MY2 FINAL MONITORING REPORT
Buffalo Creek Tributaries Mitigation Project
Johnston County
Neuse River Basin
CU 03020201

DMS Project # 100042
DMS Contract # 7422
DMS RFP # 16-007279
USACE Action ID Number: SAW-2018-00425
DWR Project # 2018-0199 V2
Calendar Year of Data Collection: 2022

RE: WLS Responses to NCDEQ DMS Review Comments for Task 8 Submittal, Draft Monitoring Year 2 Report for the Buffalo Creek Tributaries Mitigation Project, DMS Full-Delivery Project ID #100042, Contract #7422, Neuse River Basin, Cataloging Unit 03020201, Johnston County, NC

1.3 Current Condition Plan View

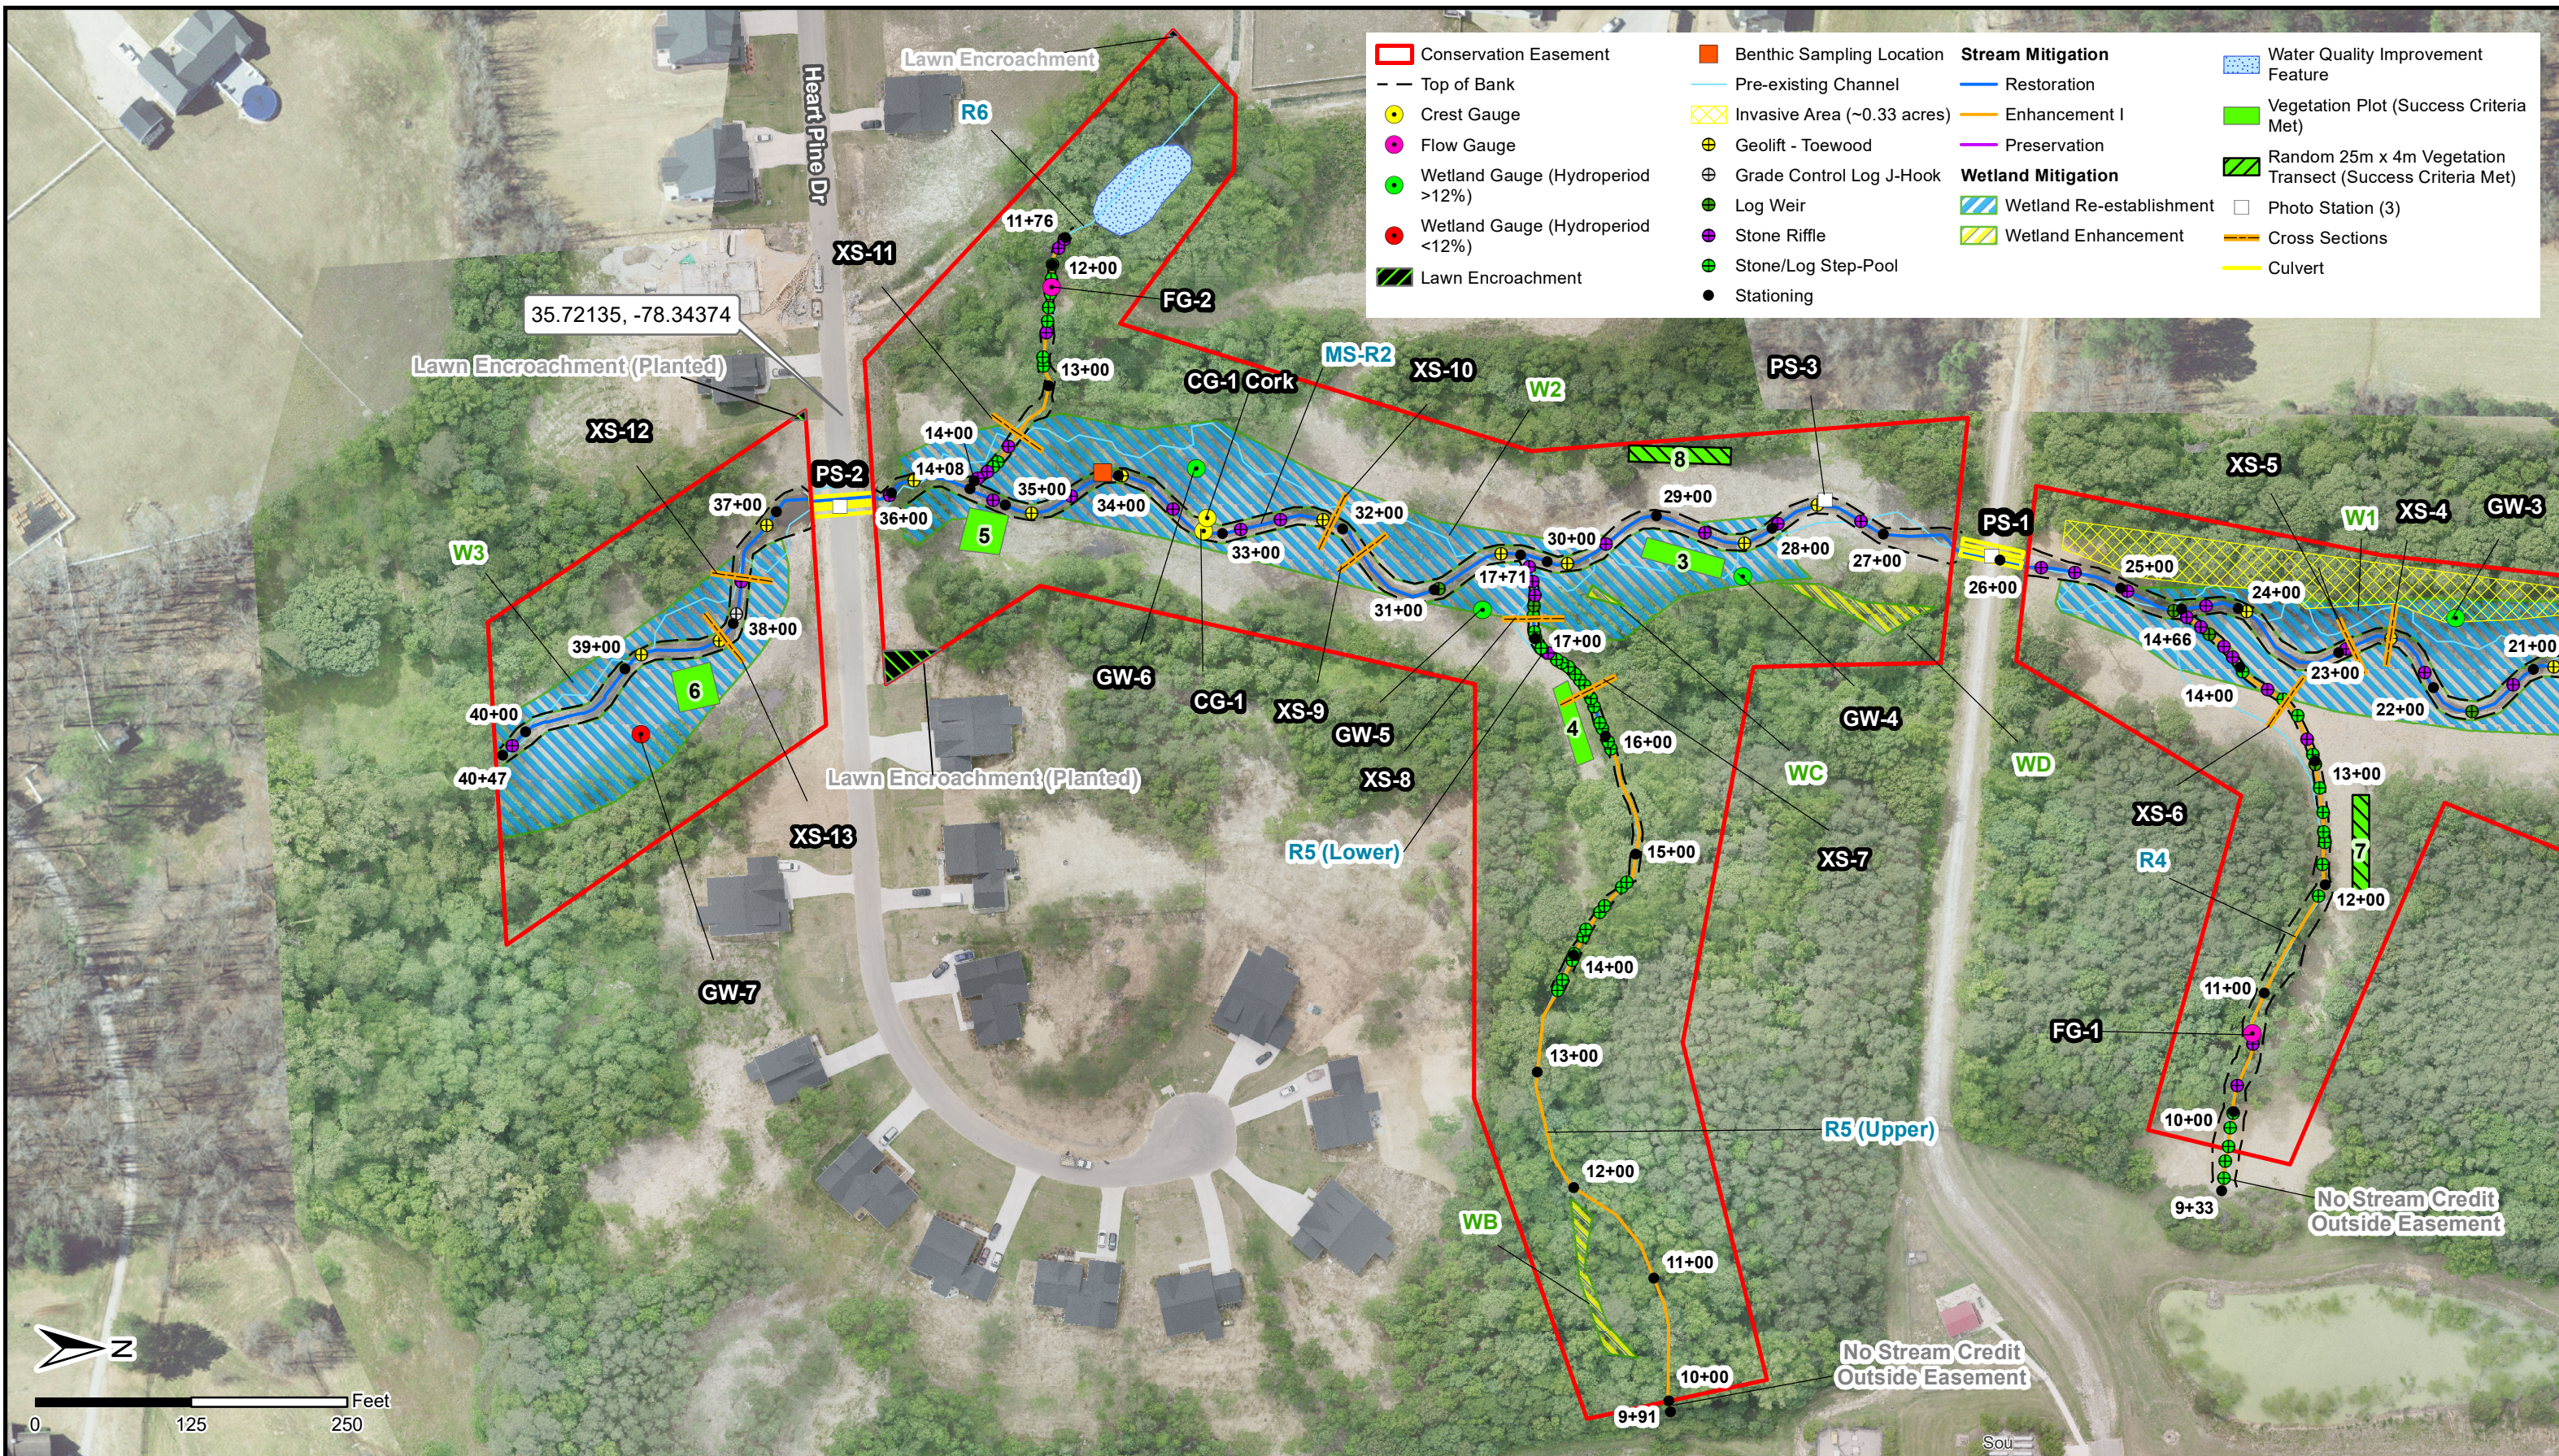
1. **Suggest adding hydroperiod label to ccpv for wetland gages in future monitoring years.**
WLS Response: The hydroperiod success criteria for wetland gauges has been added to CCPVs in the final monitoring report. WLS will continue to specify the hydroperiod on the CCPV figure in future monitoring years.
2. **Suggest checking seal on GW-7 sometime before MY3 growing season to ensure bentonite still intact.** WLS Response: WLS will check seal on GW-7 before the MY3 growing season to ensure bentonite is still intact.

9/16/2022
End of MY2 Data

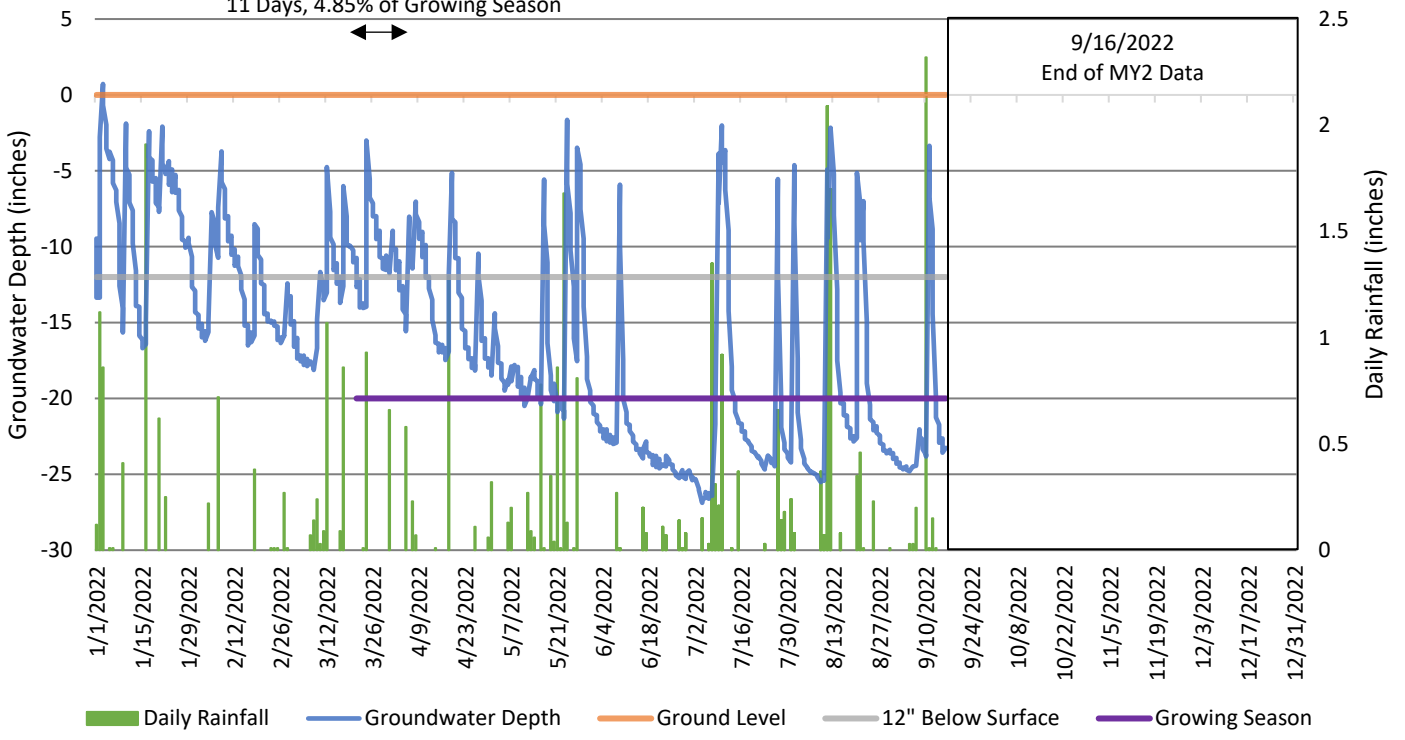
5. **Growing season for groundwater gages is through 11/3. Provide hydro data through that date if possible or explain if the entire length of growing season was used for calculations (i.e. did WLS assume worse case/no saturation from 9/14 on and use the total number of days for the denominator?).** WLS Response: The entire length of the growing season was used for calculations. WLS assumed no saturation from 9/14 through 11/3 to calculate the Hydroperiod, using the total number of days as the denominator to calculate percent of growing season.

Buffalo Creek Mitigation Site Rainfall Data

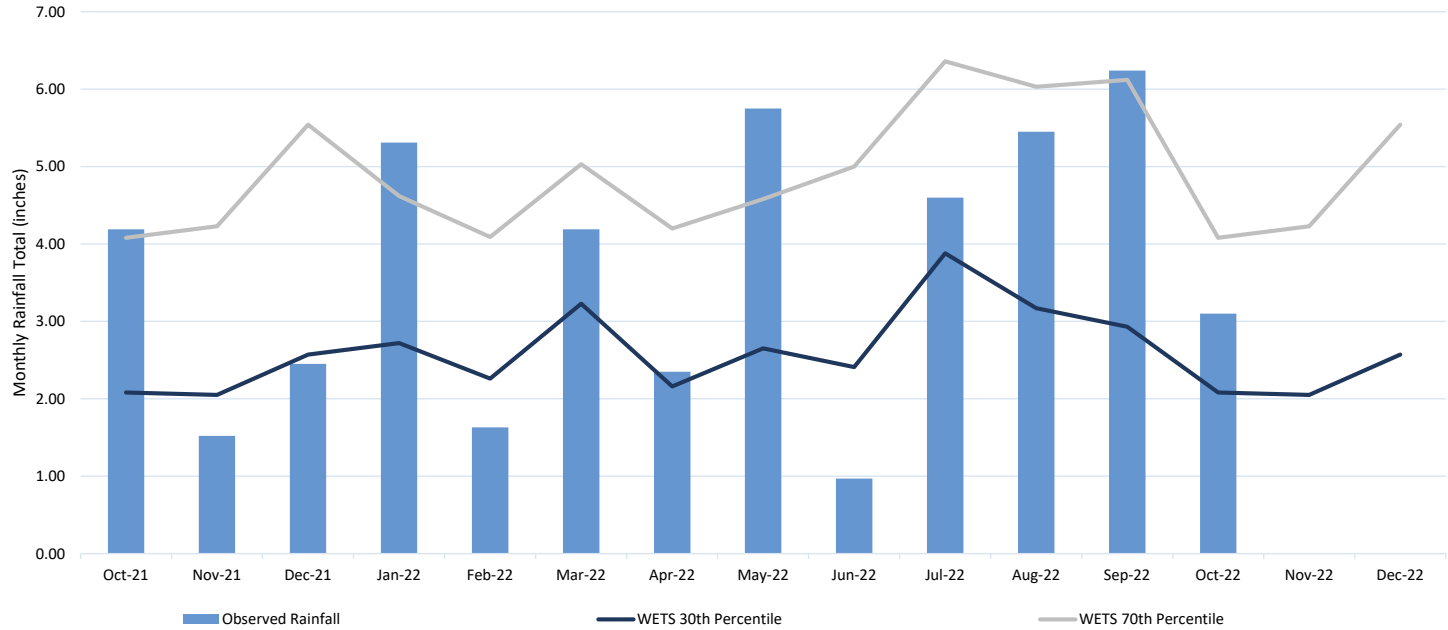
6. **Update rain data (monthly totals) to include Oct/Nov/Dec 2021 to show antecedent moisture conditions if possible.** WLS Response: Rain data is updated to show monthly rainfall totals for Oct/Nov/Dec 2021.
